# Proposed Sand and Gravel Extraction, Haddiscoe, Norfolk

## Review of Dust Assessment

Date : 12 December 2023

**MICHAEL BULL  
& ASSOCIATES**

Figure 2 Proposed Site Phasing (Source: Submitted Planning Application Drawings)

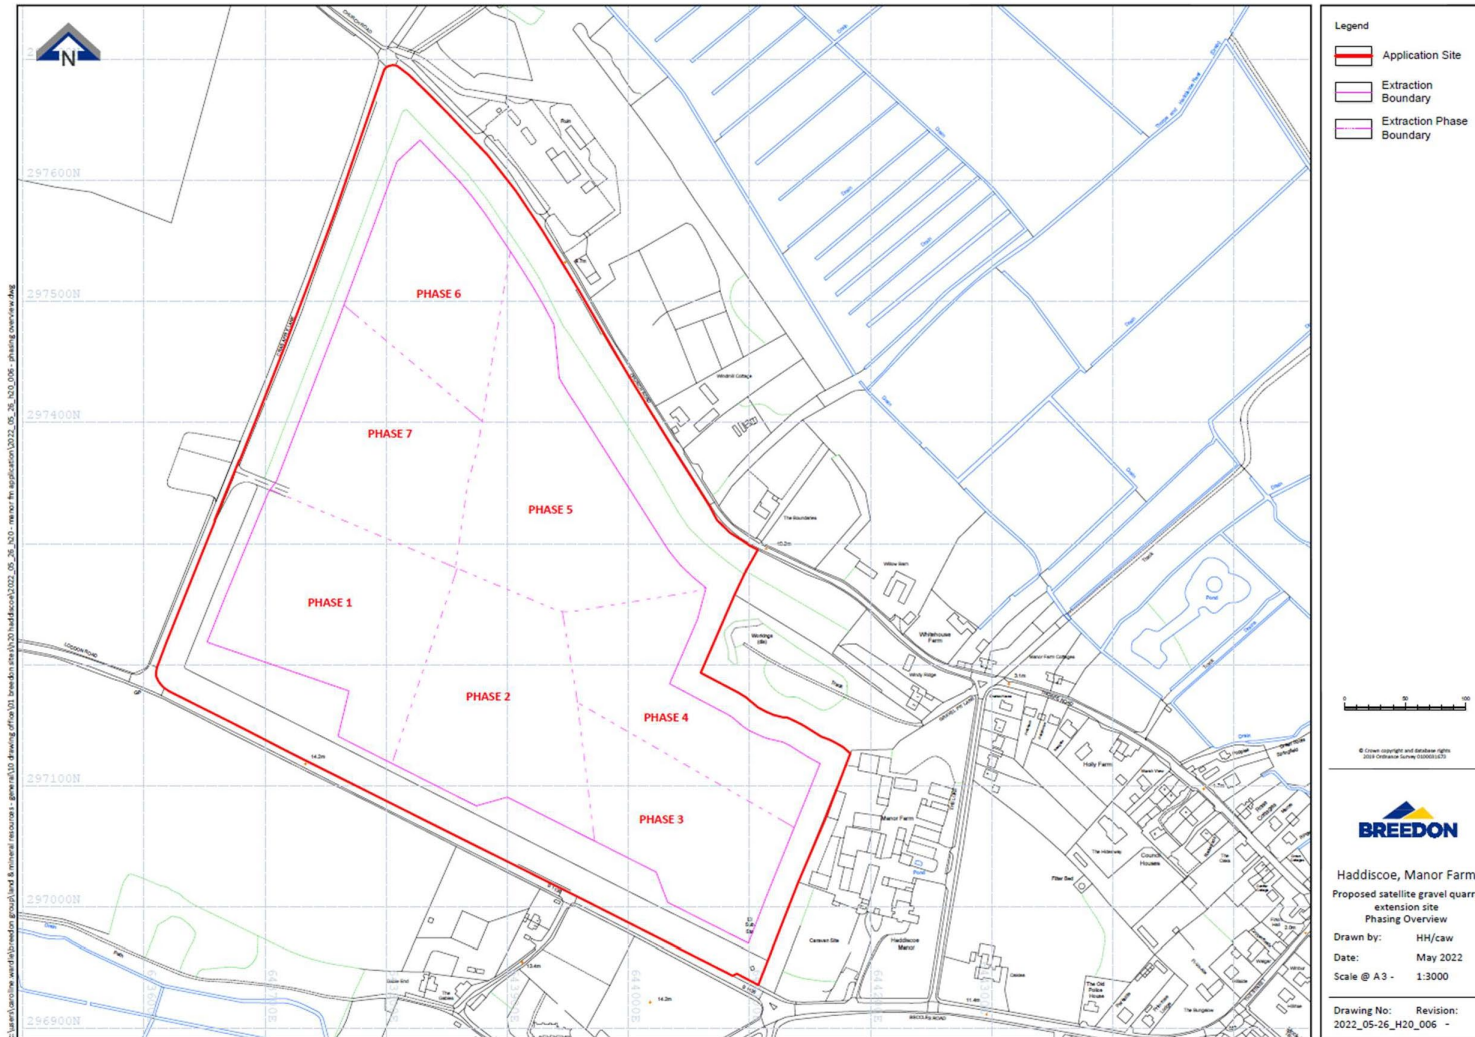
The site will be worked in seven phases as detailed in Figure 2. In each phase, topsoil and subsoil will be stripped and used for constructions of screening and storage bunds. This will then be used for restorations. Separation of sand and gravel will take place on site, the gravel to be transported offsite for further processing. Extraction activities will take place at least 100m from properties but the site boundary is within 40m of sensitive receptors. Some dust producing activities such as bund construction will take place closer than 100m from properties.

Figure 3 Phase 4 dust modelling

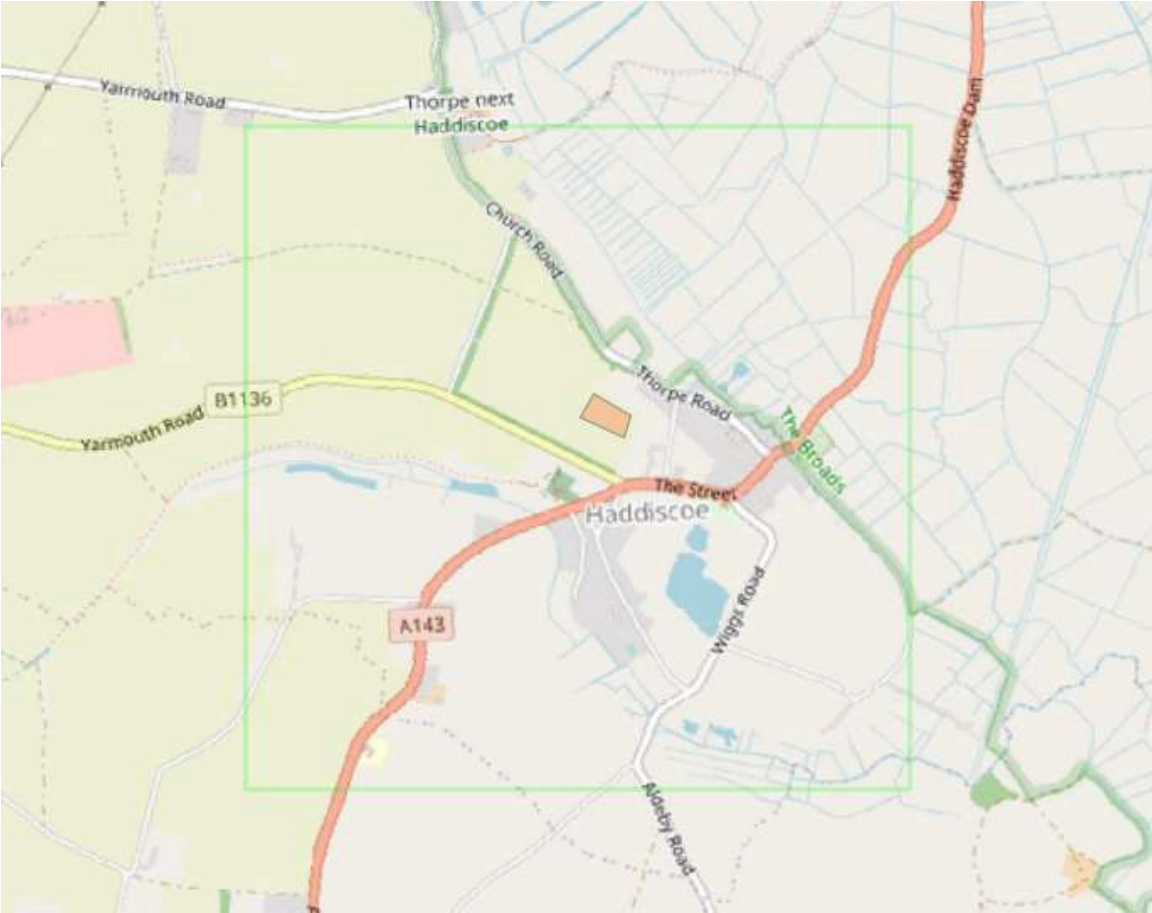
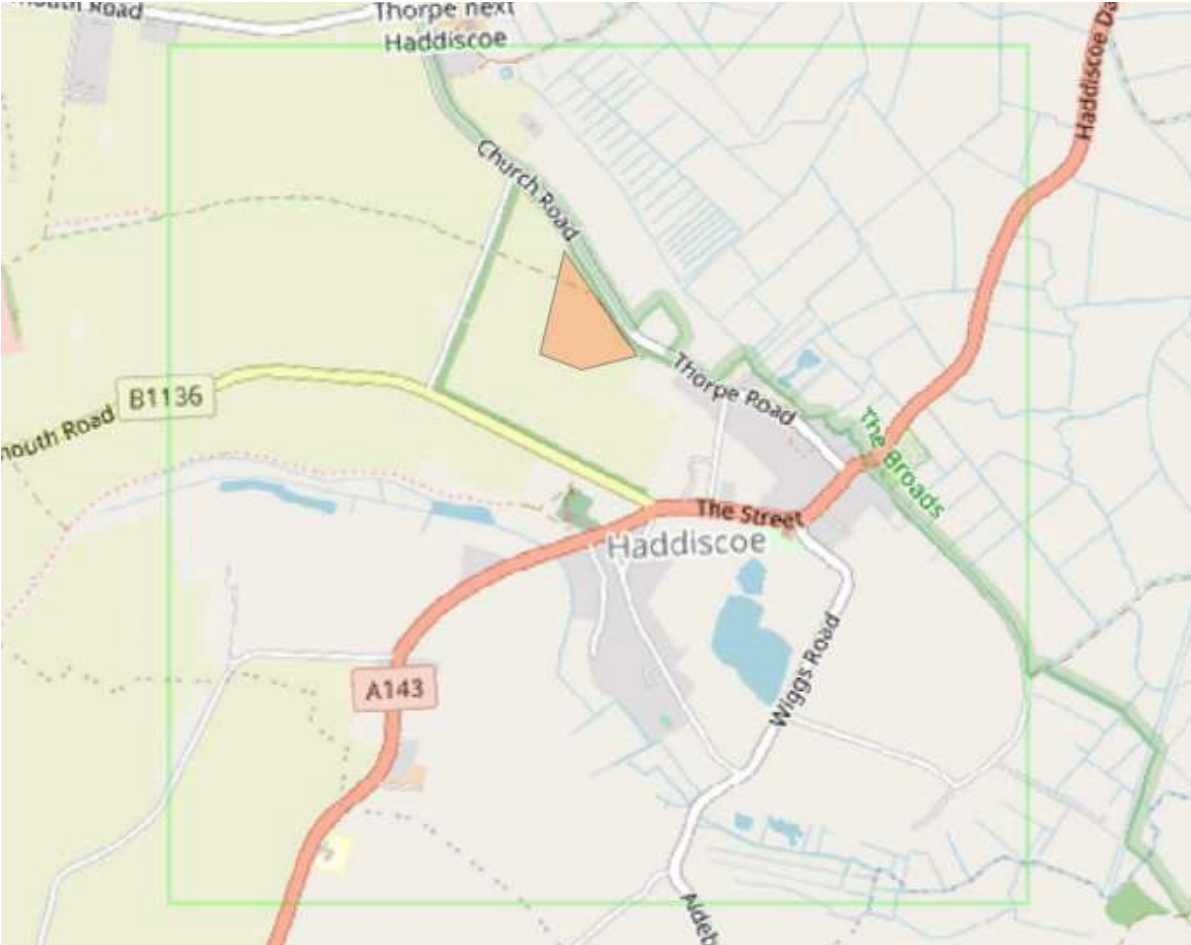
Overall particulate dust emission rates for sand and gravel extraction are provided in the National Atmospheric Emissions Inventory<sup>7</sup>. This details an emission rate of 0.1 kilotonnes per megatonne of mineral extracted (or 100 grammes per tonne). For this proposal with an extraction rate up to 100,000 tonnes a year this results in a particulate emission rate of 10,000 kg/year. This emission rate can be applied to an area source representing a phase of the development, this has been carried out for Phases 4 and 5 (see Figures 3 and 4).

Figure 5 Predicted increase in annual mean particulate levels ( $\mu\text{g}/\text{m}^3$ ) - Phase 4

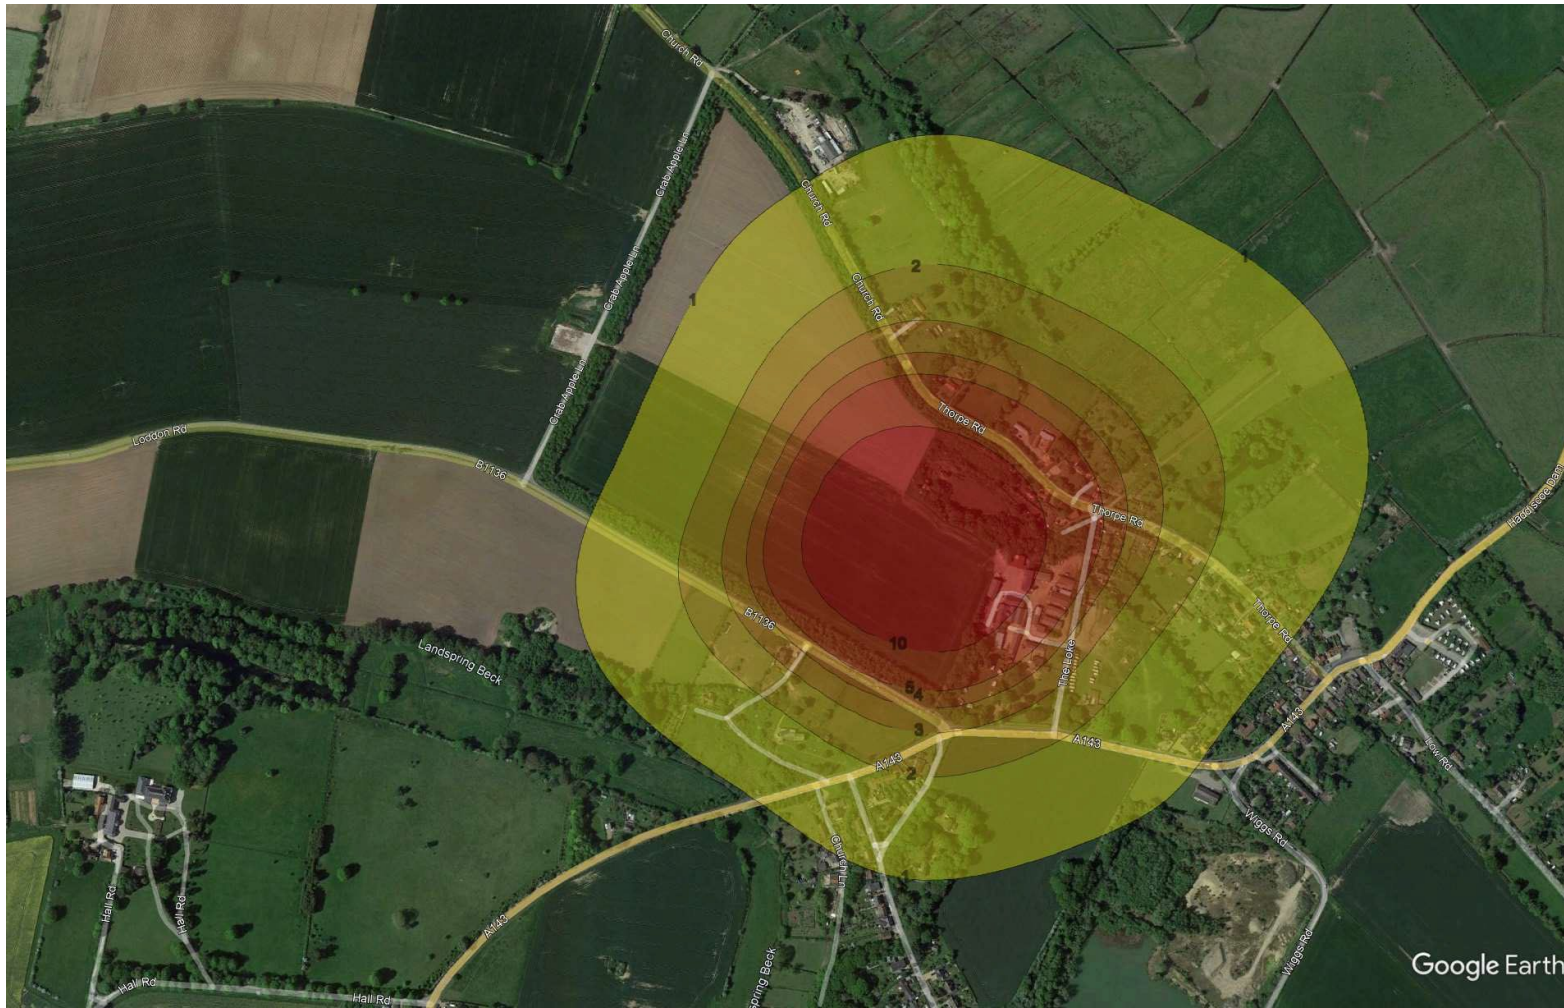
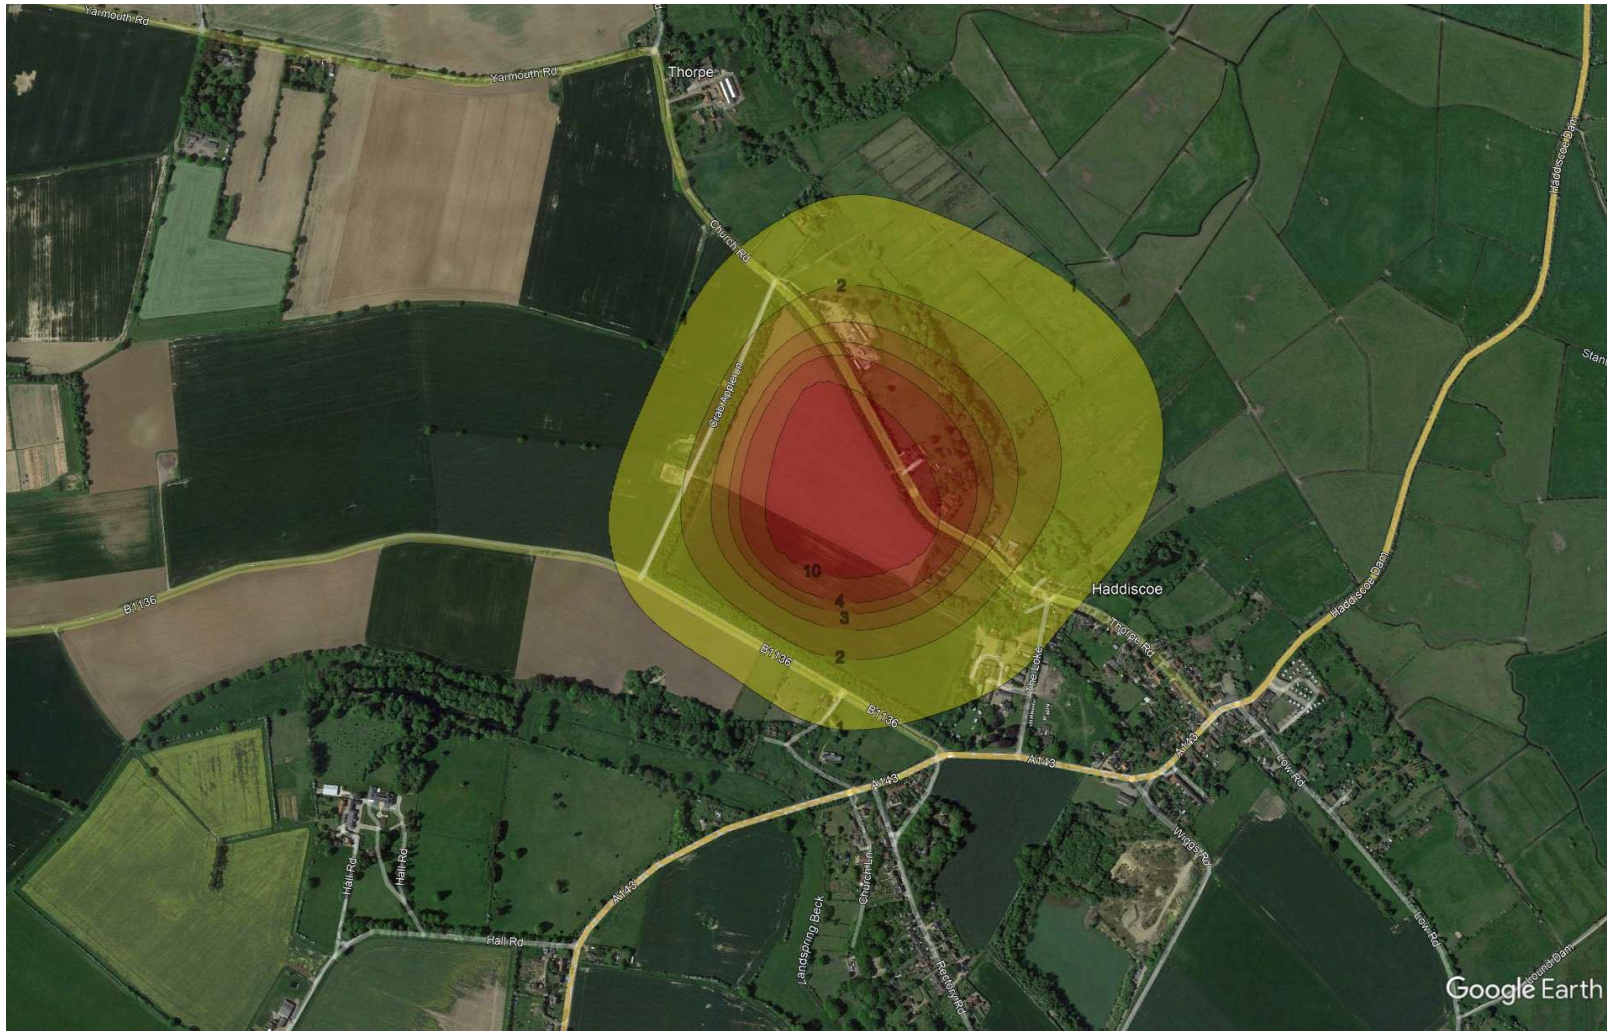
The results are shown in Figure 5 and 6 for Phases 4 and 5 respectively. The increase in annual mean particulate concentrations in is up to 10  $\mu\text{g}/\text{m}^3$  at residential properties. This increase is for total particulate but it would be expected (using information from the NAEI) that 50% of this would be  $\text{PM}_{10}$ . Monitoring of  $\text{PM}_{2.5}$  levels near to sand and gravel works has shown that  $\text{PM}_{2.5}$  levels are around 56% of the  $\text{PM}_{10}$  levels<sup>8</sup>. This suggests that  $\text{PM}_{2.5}$  concentrations could increase by 2-3  $\mu\text{g}/\text{m}^3$ . This represents a change of up to 25% of the air quality assessment level (i.e. the  $\text{PM}_{2.5}$  target set by the UK government ). This would represent a moderate to substantial impact according to the EPUK/IAQM guidance (see Table 2). Stopit2 has counted the properties and residents within 400m of the proposal and there are 106 houses and approximately 205 people within this distance who would be affected by increases in particulate concentrations. Given the numbers of people potentially affected by the development, the developer should undertake a quantitative dust assessment and compare the results within the revised particulate standards particularly for  $\text{PM}_{2.5}$ .

Figure 7 Terrain Heights used in Model

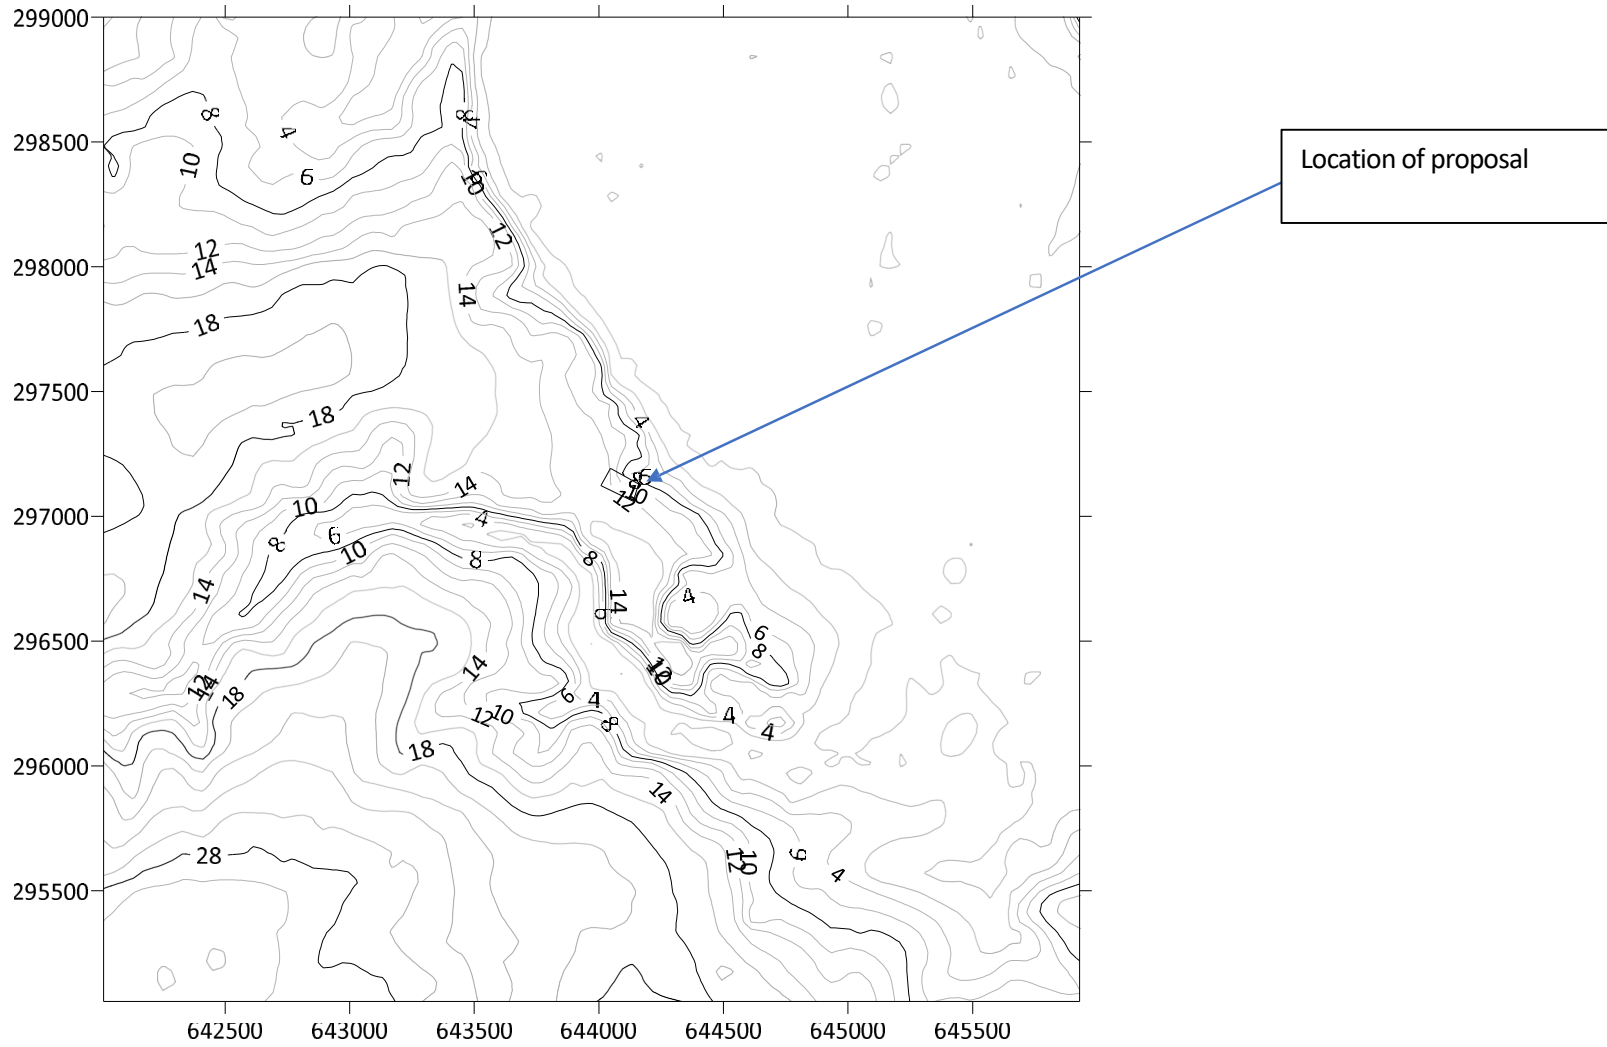
Changes in terrain height can affect wind speed and direction, these changes would then also affect how particulates disperse from the proposed development site. The terrain heights in the area have been obtained from OS Terrain 50 files and those used in the modelling are shown in Figure 7. As can be seen, the area is characterized by very flat and low terrain to the north east with a higher ridge (with a small valley running roughly north east to south west). The proposal is on the north east face of the ridge. This will result in changes in wind speed and direction in the area.
